Soil and Water Question 2a Appendix

Best Management Practices Implementation and Effectiveness Monitoring Petersburg Ranger District Road Storage Trip Report – Mitkof and Kuiu September 2012

Picture 7. Road 6409 MP 2.016 after 48" CMP removed from anadromous fish stream. Excessive fill left in channel.

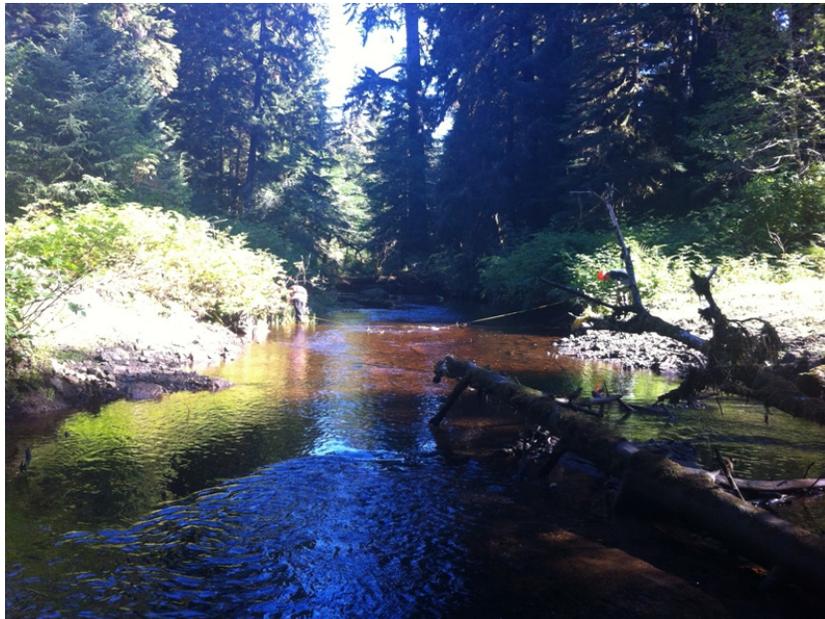
- Kuiu Road 6409: Removal of culverts from fish streams did not meet contract specifications for excavating to the streambed's original elevations. Excessive road fill left in channels resulted in channel widening through the road prism and potential barriers to fish passage at low flows (picture 7). Bridge removal from a fish stream did not restore streambanks to natural channel bed width (pictures 1 and 7). Since no equipment is mobilized on Kuiu Island, the cost is not justified to return equipment to this road to correct. We recommend monitoring (including un-mapped fish stream near MP 0.3) to determine if fish passage is impaired during dry seasons. Hand work or blasting may be necessary in the future.

- Continue increased efforts to fully implement specifications for fill removal from fish streams when culverts and bridges are removed. Ensure that all roads with fish stream crossings are inspected during contract implementation.

- Review bridge removal drawings to ensure they address fill removal from streams to restore natural stream width.
- Increase awareness of potential for fish streams that were not identified in Road Condition Survey. Roads with fish stream potential should be high priority for aquatic specialist field verification of work items prior to contract development.
